Rev.	Date	Description
/	20.12.13	Planning Submission
A	29.08.14	Planning Revision: - Rear recess built out for PH - Front door recess made legs shallower for SBD - Internal layout reconfigured - Stair Clarified

Client	LB Camden
Job Name	Agar Grove
Job No.	1237
Title	Plot F Ground Floor Plan
Status	Planning
Scale	1:100
Drawn By	FY
Checked By	JH
Date	29.08.14
Drawing No.	1423_DWG_PL_F_00_200
Revision	A

Client LB Camden	Job Name Agar Grove	Job No. 1237
Title Plot F First Floor Plan	Status Planning	Scale 1:100
Drawn By FY	Checked By JH	Date 29.08.14
Drawing No. 1423_DWG_PL_F_00_201	Revision B

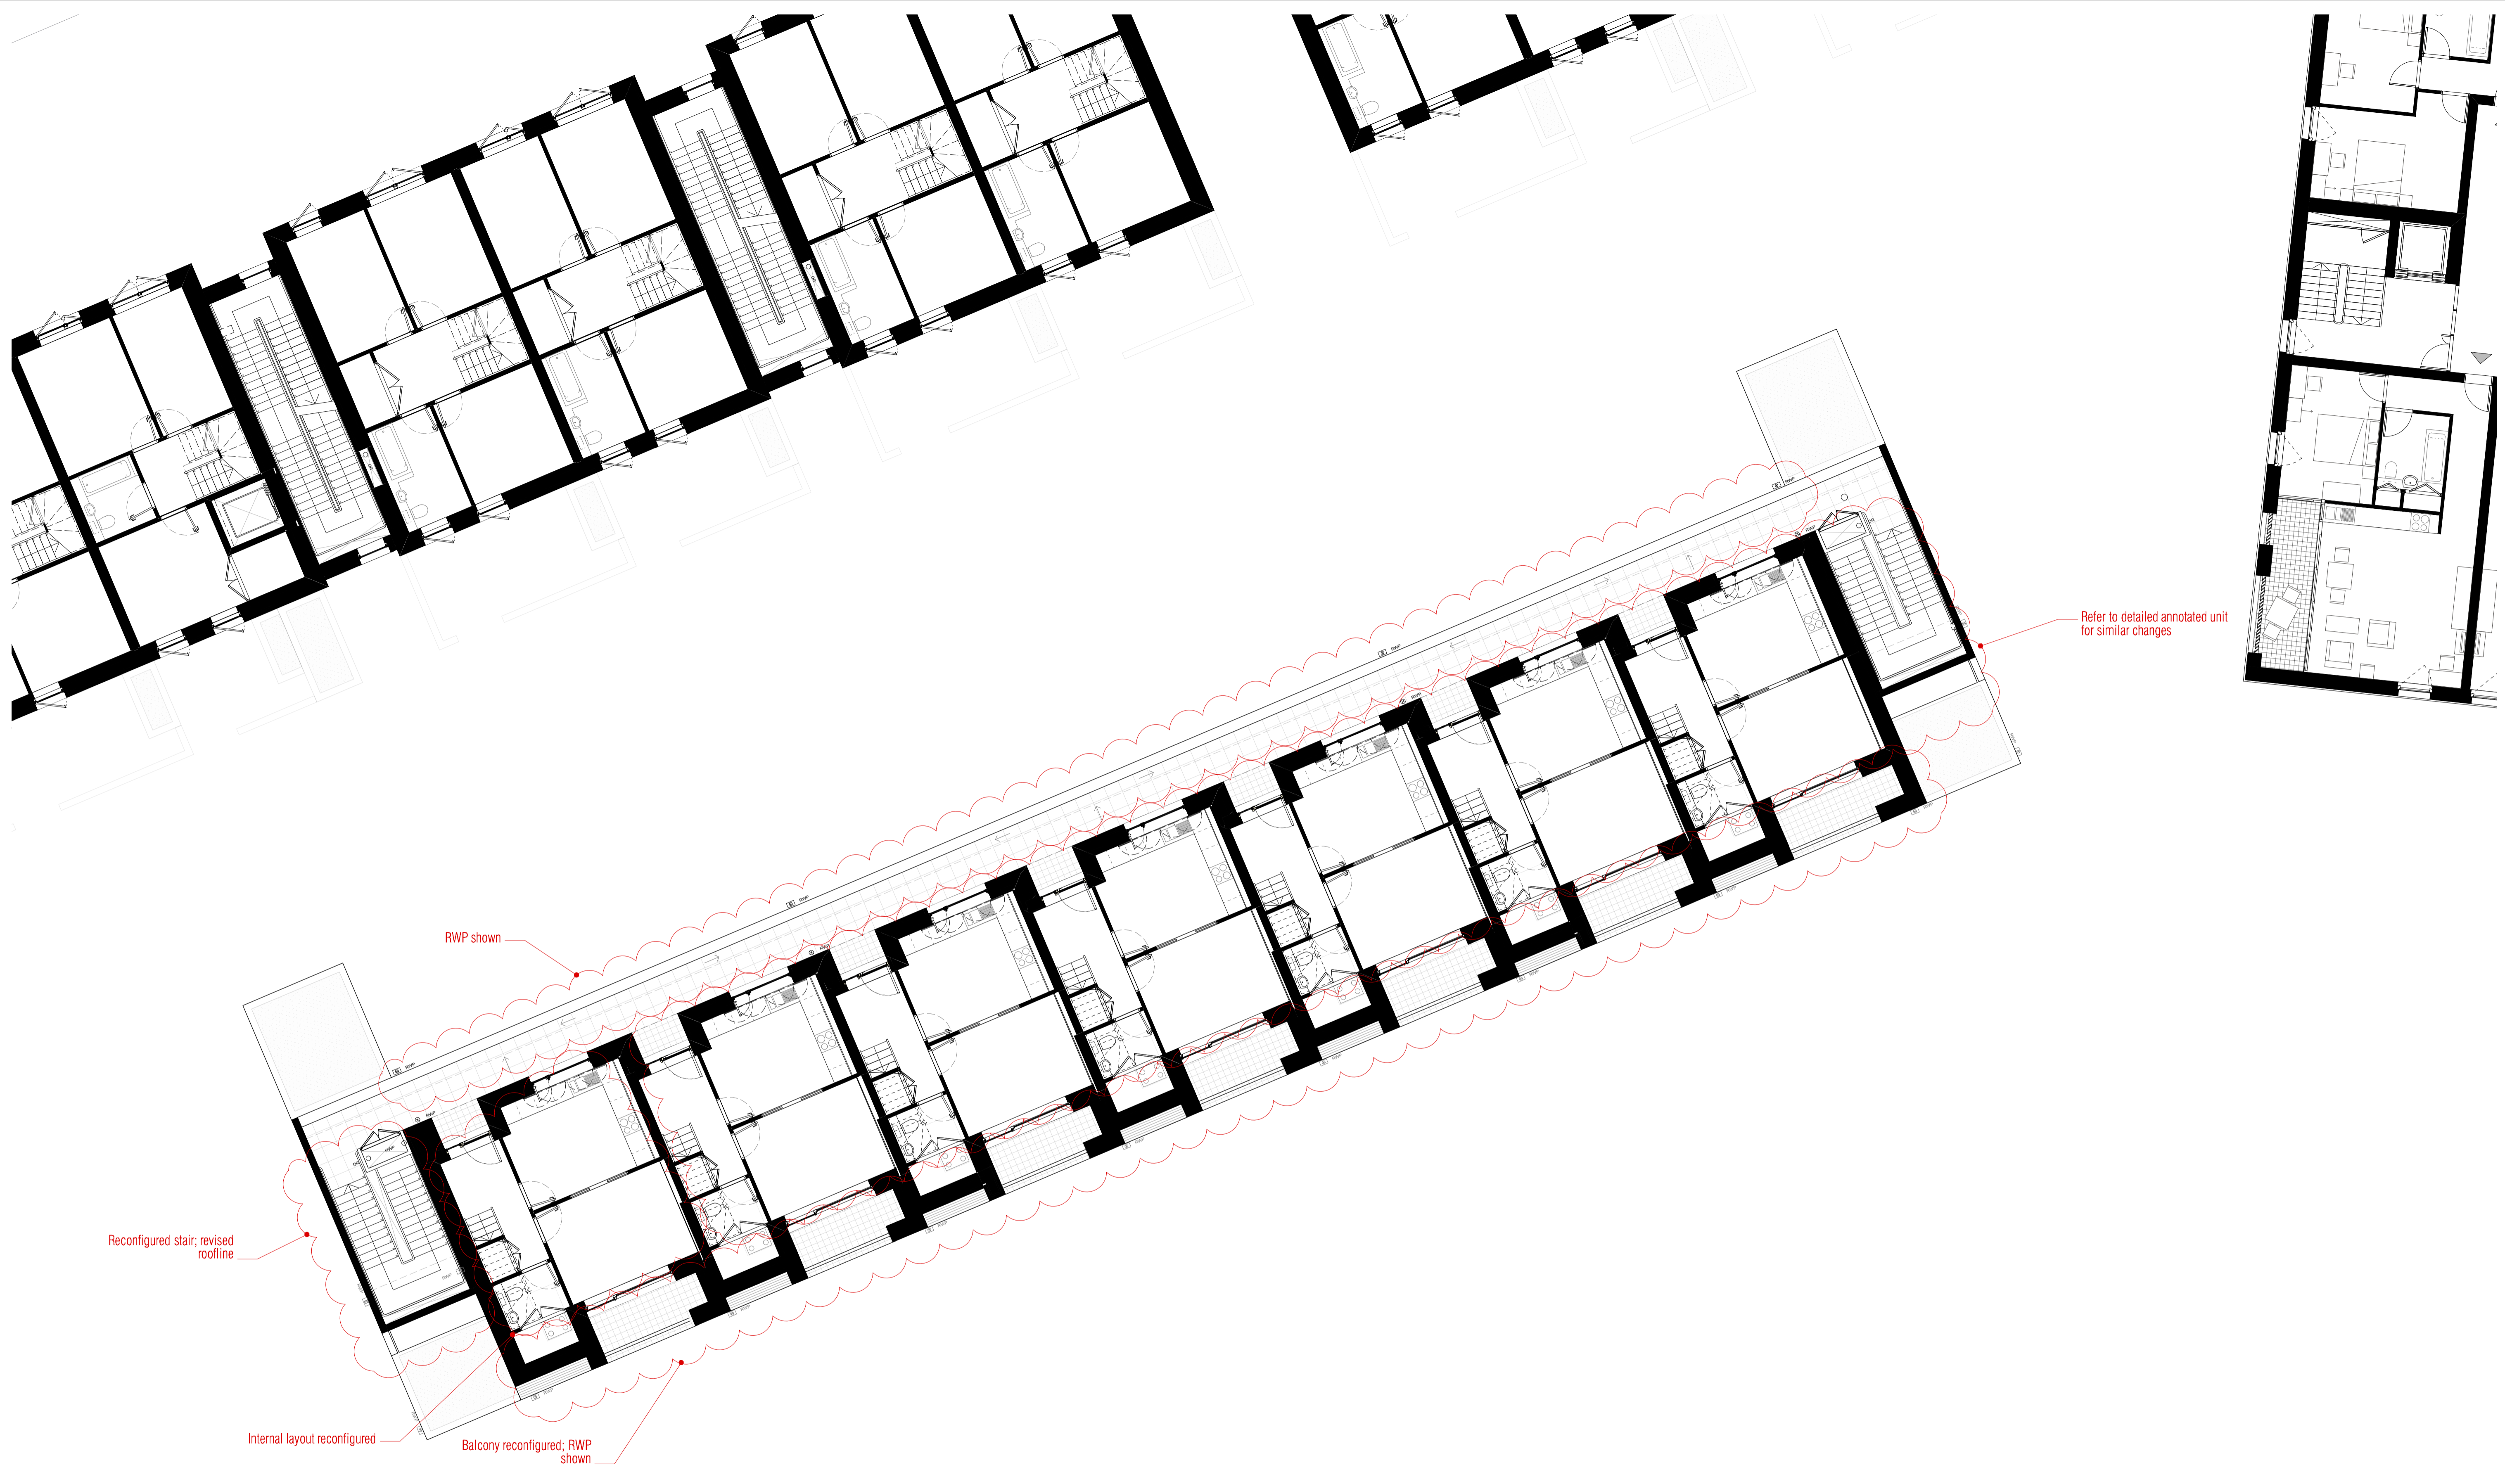
Rev.	Date	Description
/	20.12.13	Planning Submission
A	02.05.14	Planning Revision: - Annotation added to first floor studies
B	02.05.14	Planning Revision: - No. of windows reduced by no. per dwelling on this floor for PH

Refer to detailed annotated unit for similar changes

RWP shown

Reconfigured stair; revised roofline

Internal layout reconfigured

Balcony reconfigured; RWP shown

Client	LB Camden
Job Name	Agar Grove
Job No.	1237
Title	Plot F Second Floor Plan
Status	Planning
Scale	1:100
Drawn By	FY
Checked By	JH
Date	29.08.14
Drawing No.	1423_DWG_PL_F_00_202
Revision	A

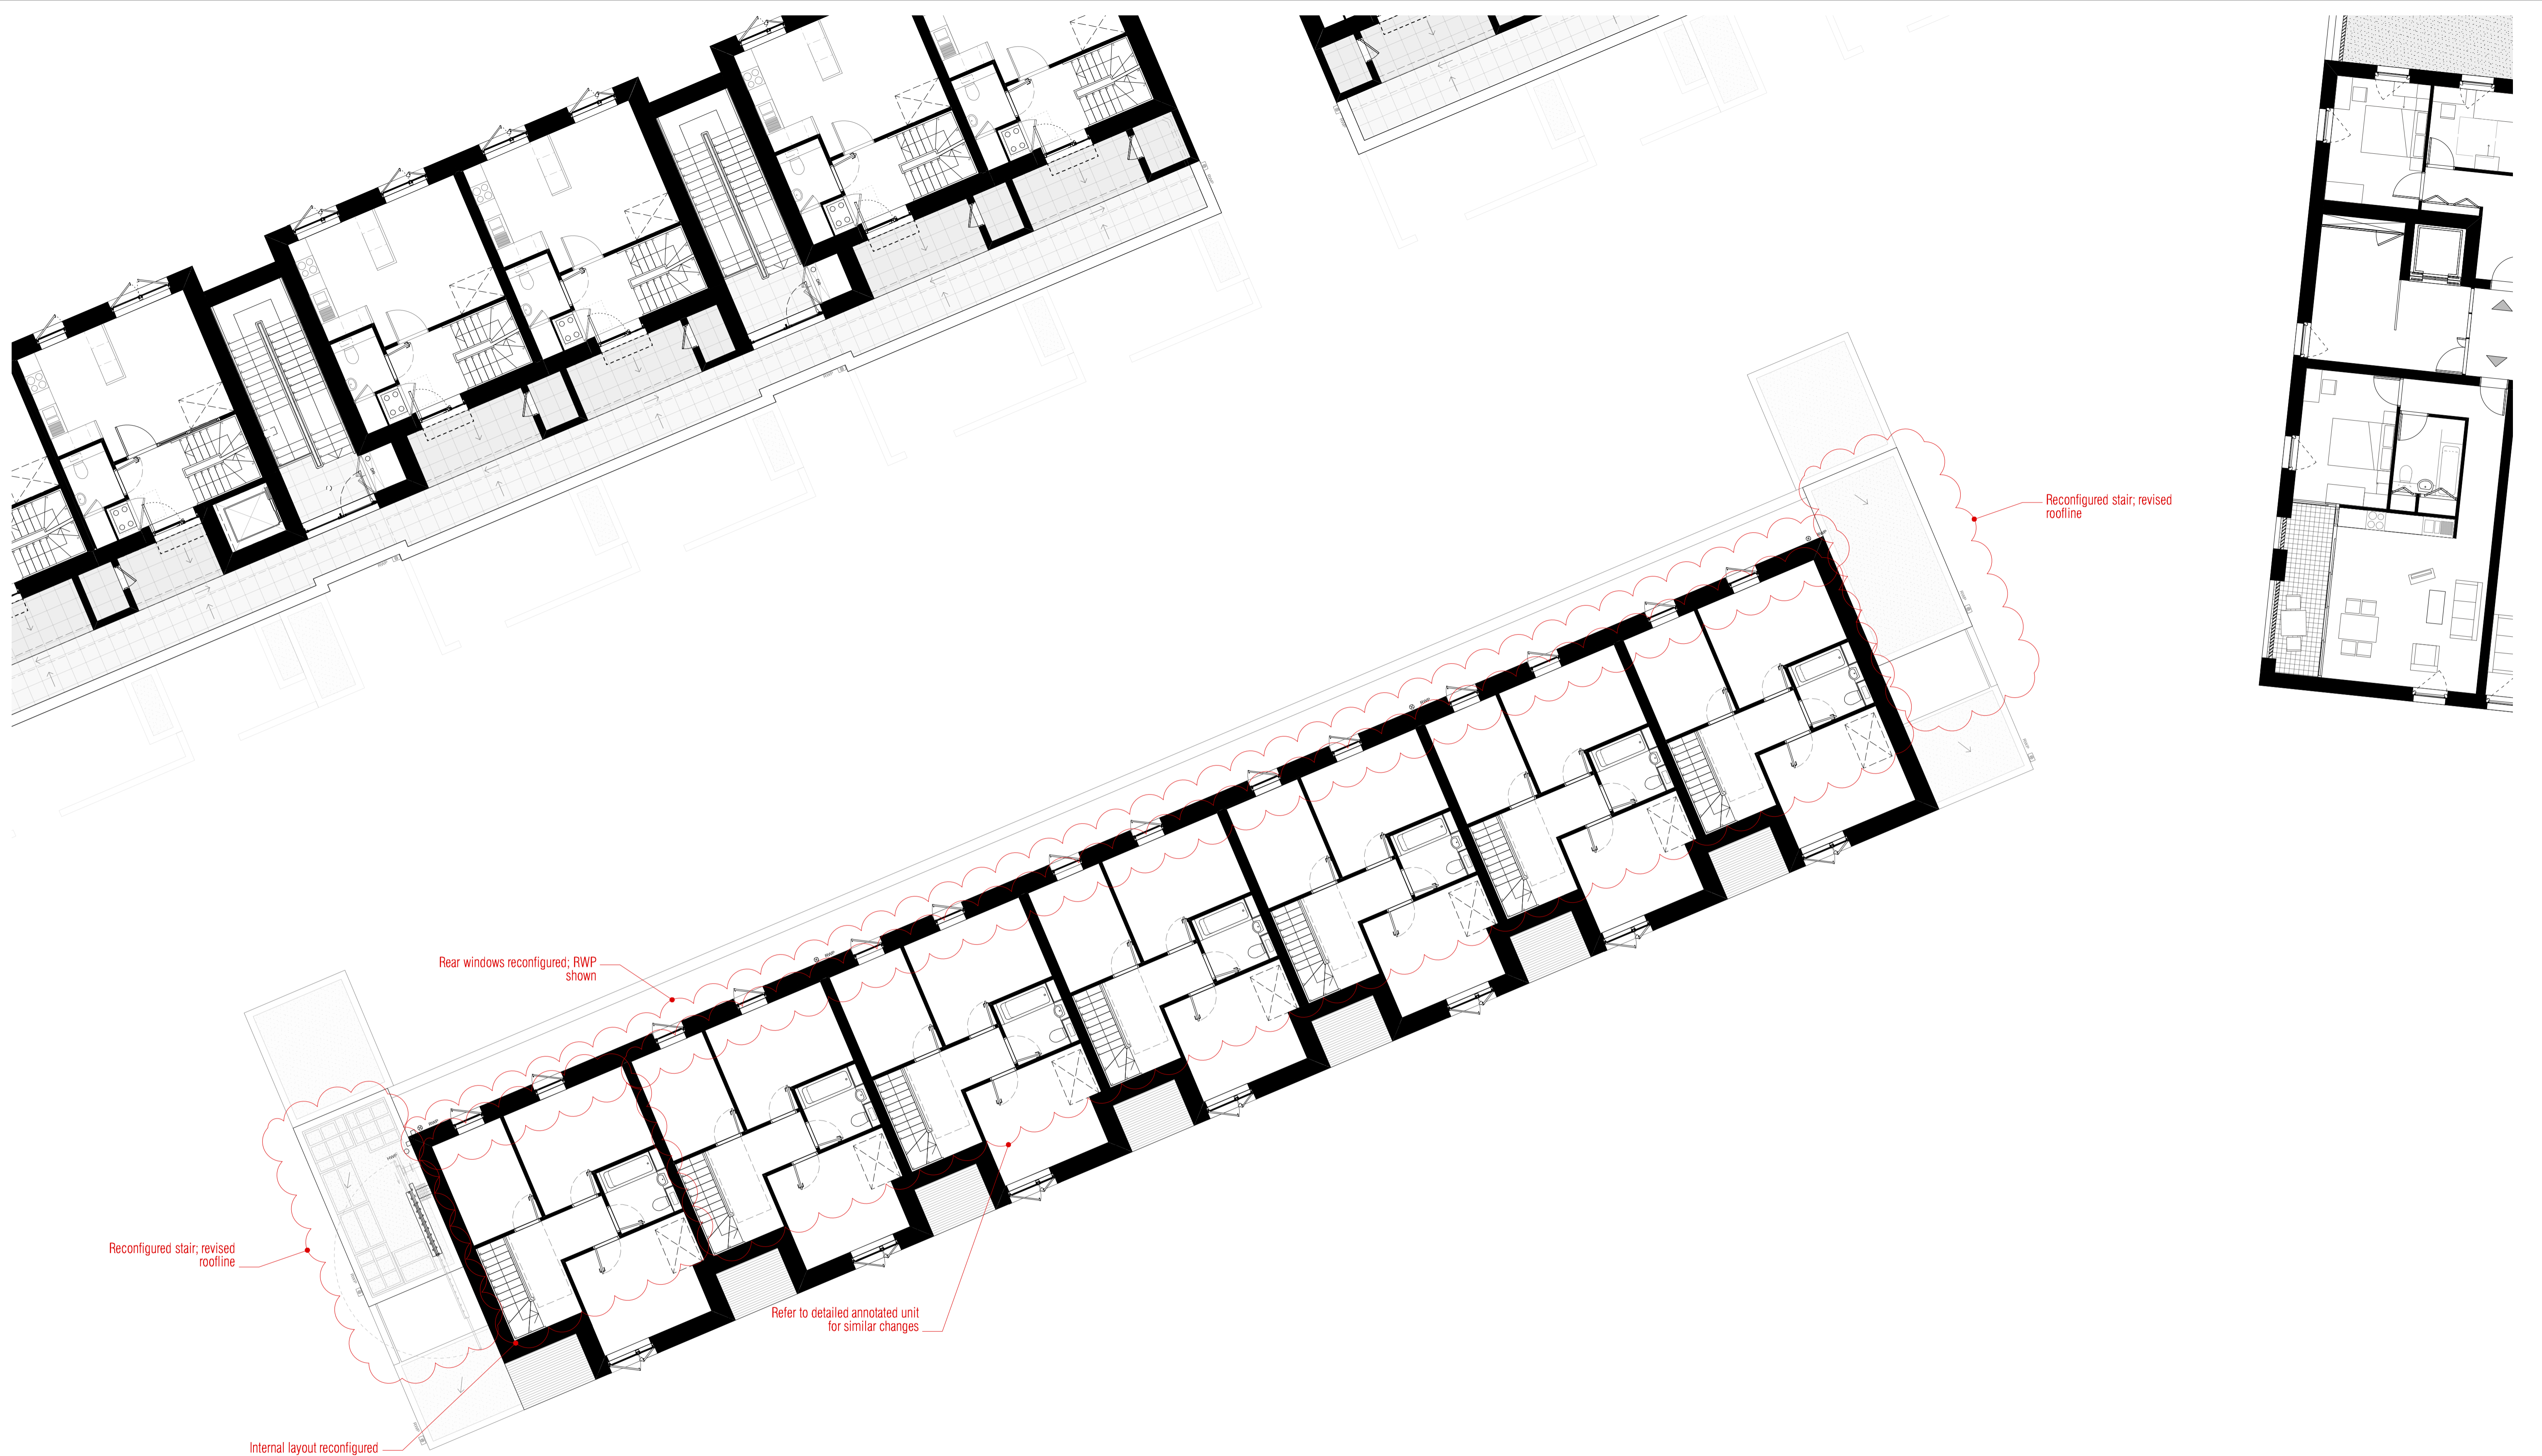
Rev.	Date	Description
/	20.12.13	Planning Submission
A	12.07.14	Planning Revision: - Balcony reduced due to wall buildup increase as result of FPH, note resultant size is below LNHG standard
